**Date:** March 10, 2020  
**To:** Planning Board  
**From:** Kellie Walsh, Town Planner  
**Subject:** Frederick & Celia Lorden Trust (owner) and Ponemah Hills, LLC (applicant) – Review for consideration of final approval for a major site plan to construct a 6,447 square foot, 9-unit multifamily residential building with a nine stall carport along with associated site improvements. The parcel is located at 0 Ponemah Hill Road in the Residence B District. Tax Map 43, Lot 61. *Postponed from March 17 and April 7, 2020.*

**Re: Ponemah Pines Site Plan, Ponemah Hill Road (Map 43, Lot 61)  
Drainage Review**

**Re: Interdepartmental Review Map 43 Lot 61  
Ponemah Pines LLC Site Development Plans  
19 Ponemah Hill Rd**

SITE DEVELOPMENT PLANS  
**PONEMAH PINES**

**SITE PLAN**  
**PONEMAH PINES**  
TAX MAP 43 PARCEL 61 - PONEMAH HILL ROAD  
MILFORD, NEW HAMPSHIRE  
PREPARED FOR:  
**PONEMAH PINES, LLC**  
476 ROUTE 13 SOUTH, MILFORD NH 03055  
LAND OF:  
**FREDERICK & CELIA LORDEN TRUST**  
19 PONEMAH HILL ROAD, MILFORD NH 03055

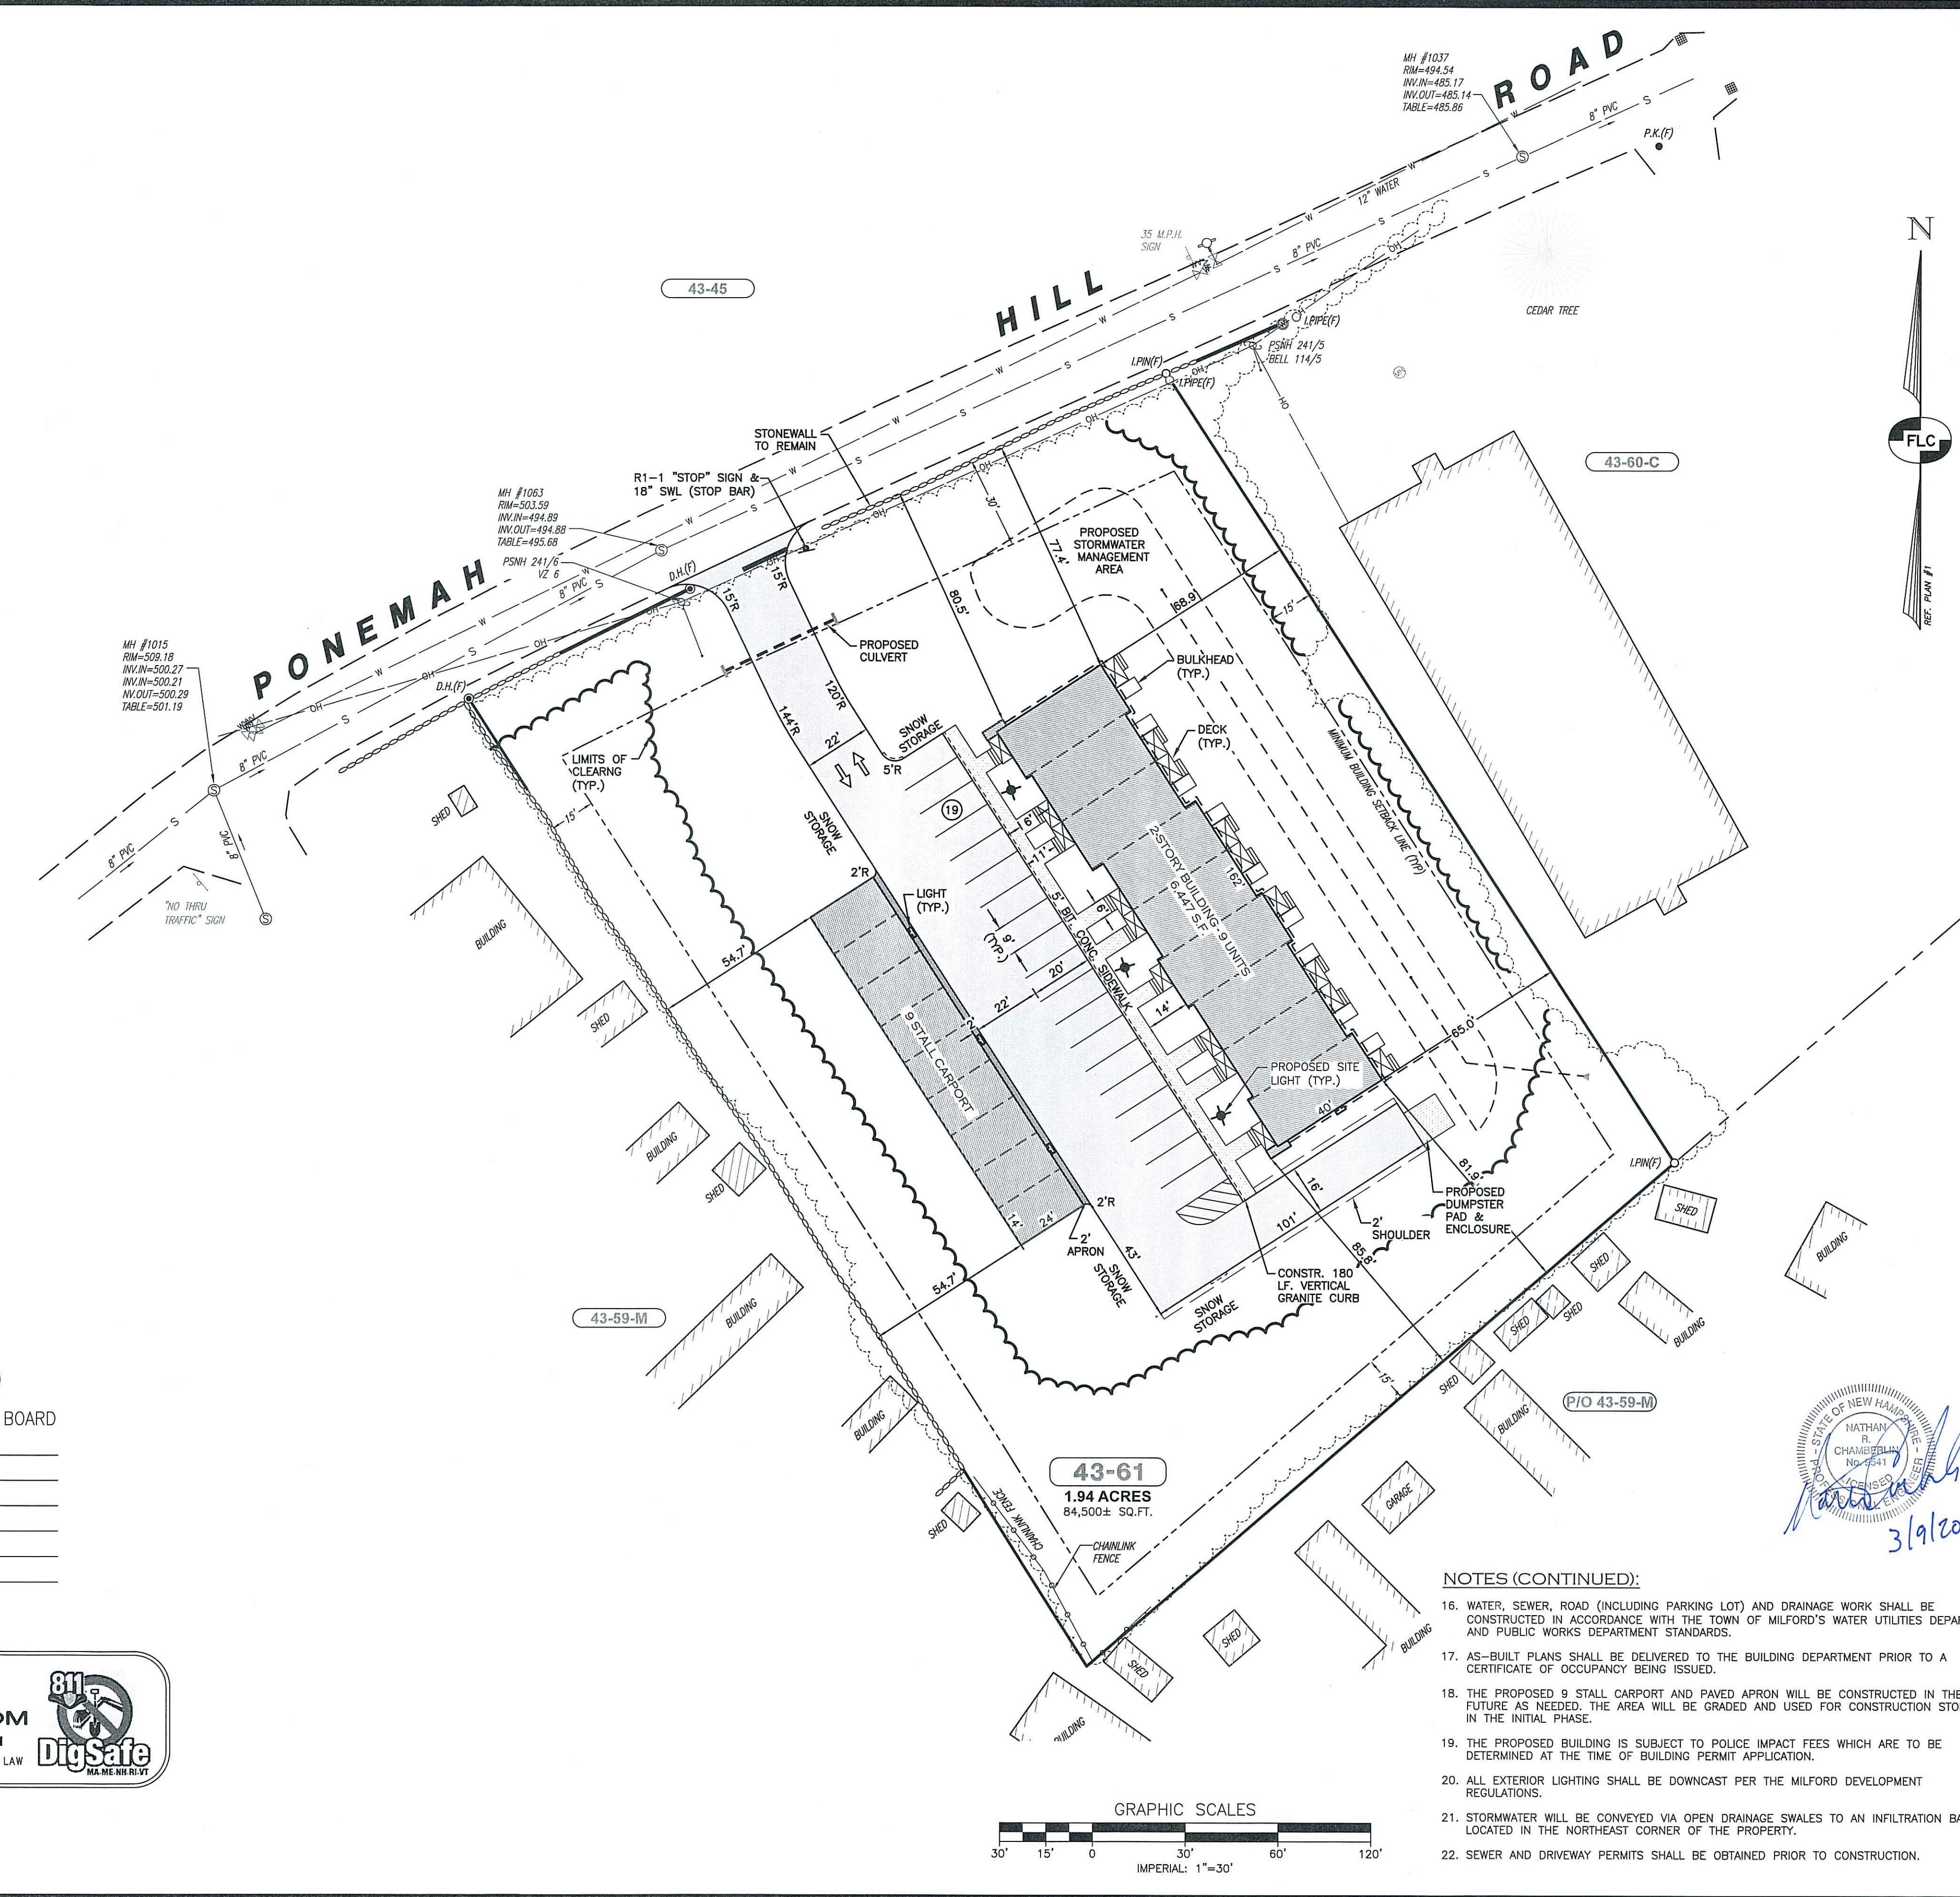
Vehicular egress and access to the property will be from a single curb cut off of Ponemah Hill Road. Designated parking areas have been provided internally on site. The applicant has revised the plan to include a 16 foot wide access on the southeast portion of the site for emergency vehicles.

The proposed parking on site meets and exceeds the minimum requirements set forth in Section 6.05.4 Table of off Street Parking which requires two (2) spaces per unit: **9 units x 2 = 18 spaces required**. The plan shows a proposed 20 spaces plus 9 carport spots.

The Board may consider discussing with the applicant the possibility of reducing the amount of parking spaces given the amount of impervious surface onsite.

1. Site Plan, Notes. Add a note stating sewer and driveway permits shall be obtained for this project. *Addressed.*
2. General Comment. Staff would recommend the applicant consider ways to decrease the amount of impervious surface onsite

such as reducing the number of parking spaces/carport spaces provided and/or reducing the width of the entrance roadway to 22 feet. *Addressed.*

21. STORMWATER WILL BE CONVEYED VIA OPEN DRAINAGE SWALES TO AN INFILTRATION BASIN LOCATED IN THE NORTHEAST CORNER OF THE PROPERTY.
22. SEWER AND DRIVEWAY PERMITS SHALL BE OBTAINED PRIOR TO CONSTRUCTION.

**LIGHTING & LANDSCAPING PLAN**

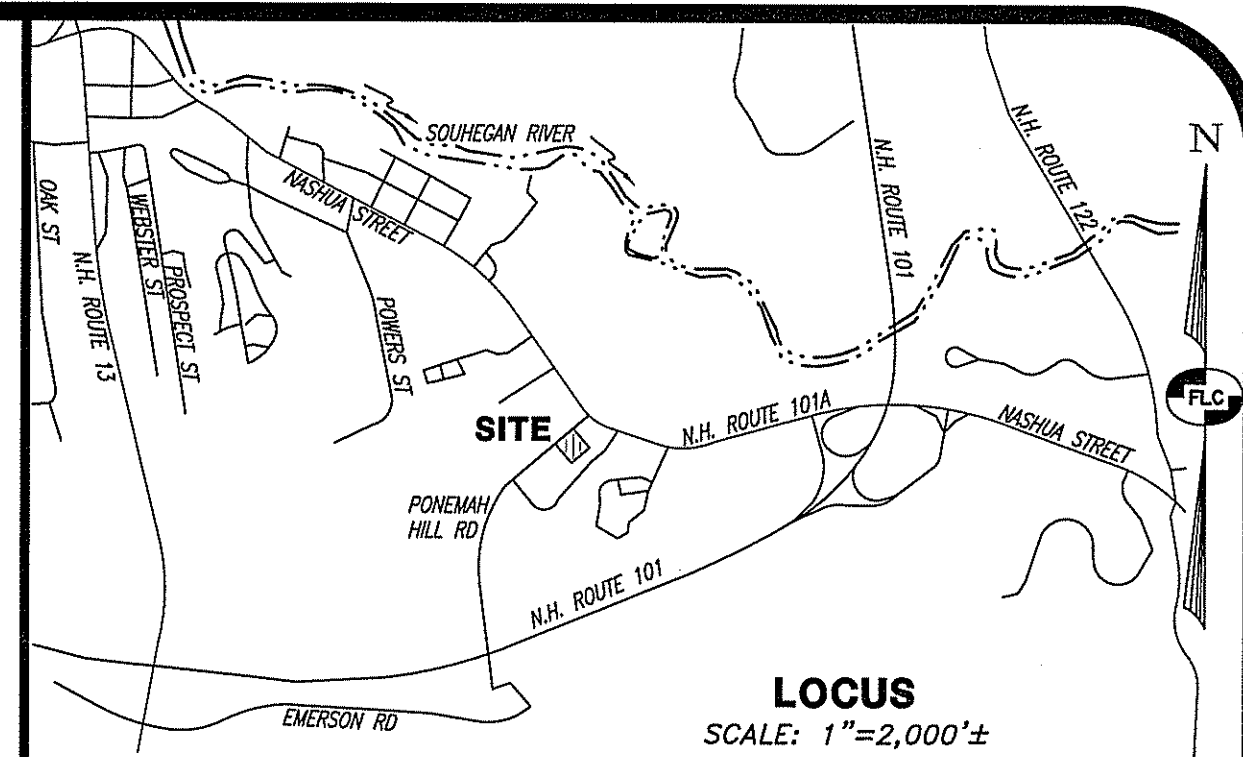
The applicant has revised the landscape plan to include additional plantings along the frontage of Ponemah Hill Road in compliance with Section 6.08.7A.2. Additional plantings (arborvitae) have been added to the eastern buffer area as discussed at the last Planning Board meeting.

Staff would recommend installing additional vegetation buffer in areas where there may be gaps.

3. General Comment. Please confirm the sight distance is adequate. There is concern about sight distance to the west while exiting the site given the curving of the road. *Addressed.*
4. Landscape Plan. Staff would recommend additional tree plantings along the frontage of Ponemah Hill Road in compliance with Section 6.08.7.A.2 requiring one tree per each 30 feet of landscaped strip along the access way (unless it can be shown that existing trees meet these requirements). *Addressed.*
5. Landscape Plan. Staff would recommend additional landscaping within the site in compliance with Section 6.08.6 requiring a minimum of 1 shrub for every 5 feet of building frontage and additional landscaping within the site that is compliant with Section 6.08.7. *Addressed.*

1. The Commission members were told that the applicant proposes to use arbor vitae for their buffer plantings. These plantings could be supplemented with columnar junipers which provide winter food for birds and other wildlife. These plants are also quite hardy in challenging soils.
2. It is unclear what the surface material will be for the proposed emergency vehicle access on the north side of the building. Would the applicant consider using geogrid with grass or other hardy groundcover planting? This will promote water infiltration and a more attractive aspect for the homeowners for an access that, hopefully, will be rarely utilized by emergency services.

- LANDSCAPING PARKING LOTS AND ACCESS WAYS CALCULATION:  
190± FT. OF LANDSCAPING BUFFER X 1 TREE PER 30' OF BUFFER = 7 TREES

A DARK AMERICAN ARBORVITAE BUFFER TO THE EAST ALONG WITH EXISTING VEGETATION TO THE WEST PROVIDE A BUFFER TO ADJACENT LOTS. LANDSCAPING ALONG FRONTAGE AND ACCESS WAY SHALL COMPLY WITH SECTION 6.08.7.A.02. A MINIMUM OF 7 TREES (OCTOBER GLORY MAPLES OR EQUAL) SHALL BE PLANTED.
- LANDSCAPING ALONG FRONTAGE CALCULATION:  
249± FT. OF FRONTAGE X 1 SHRUB PER 5' OF FRONTAGE = 50 SHRUBS

Building Elevations  
proj. no.: 2019074

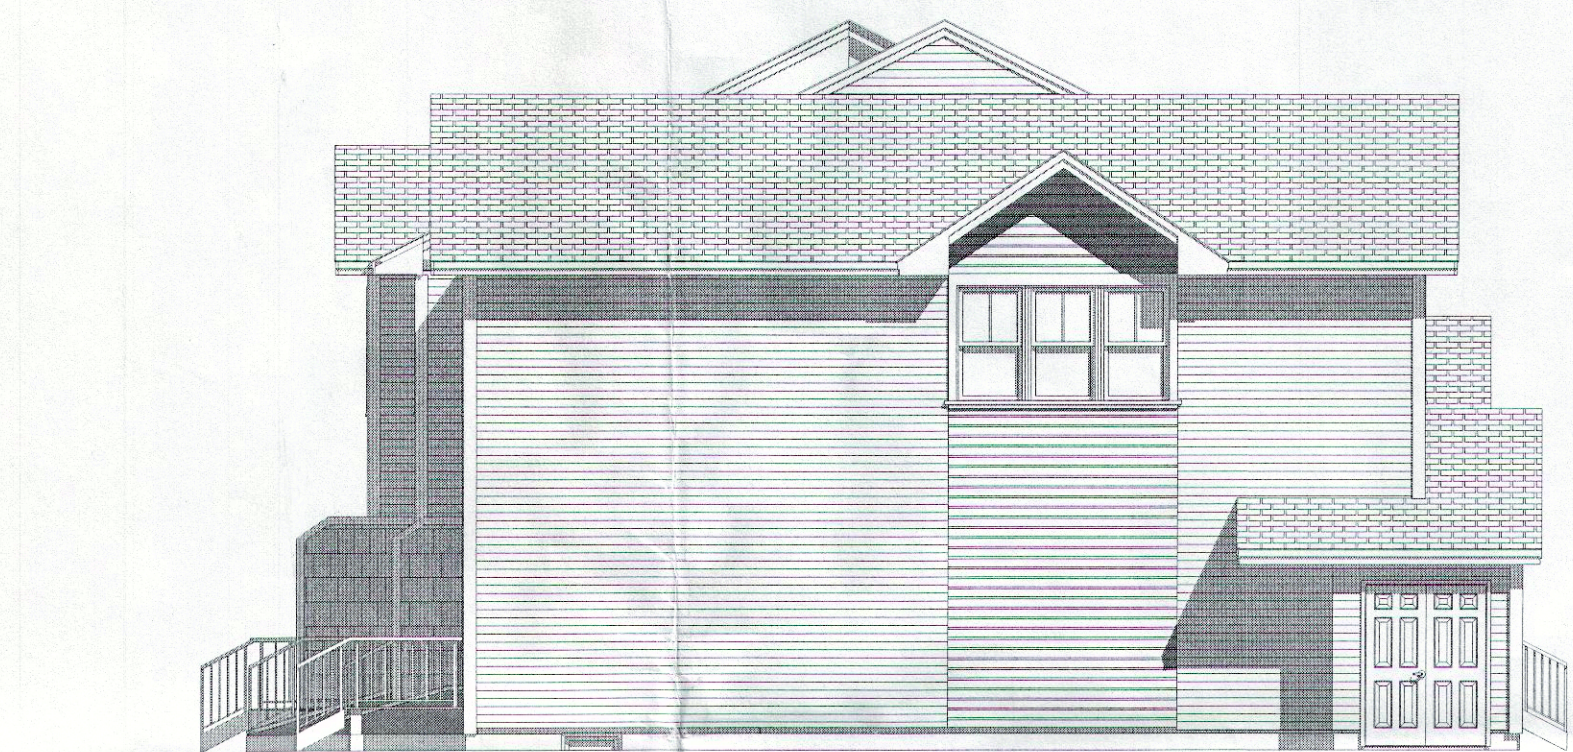
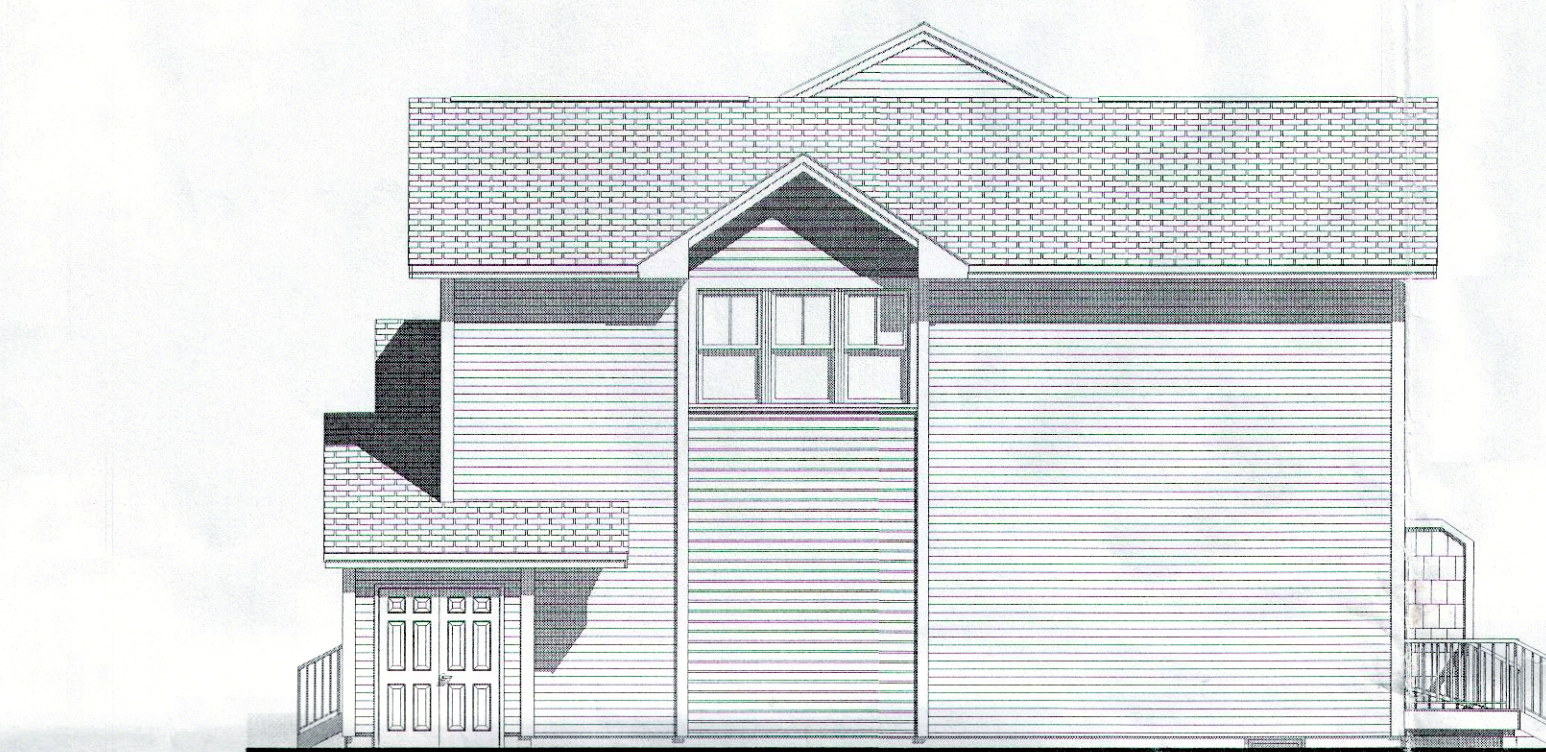
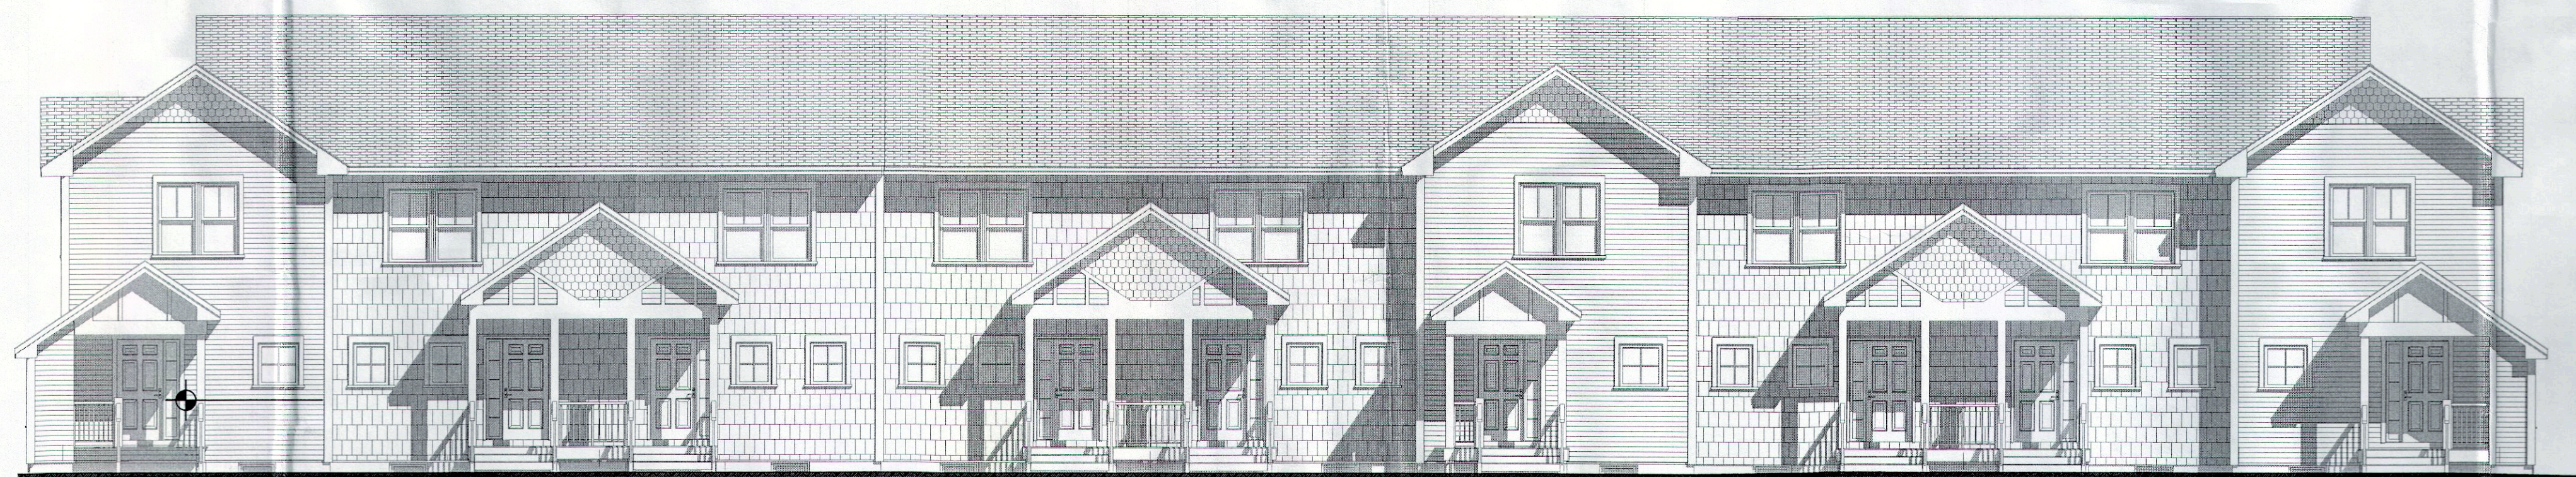
The applicant has provided the proposed building elevations for review and consideration by the Board (see attached). The proposed elevations provide the appropriate scale, massing and form when compared to the surrounding properties and buildings.
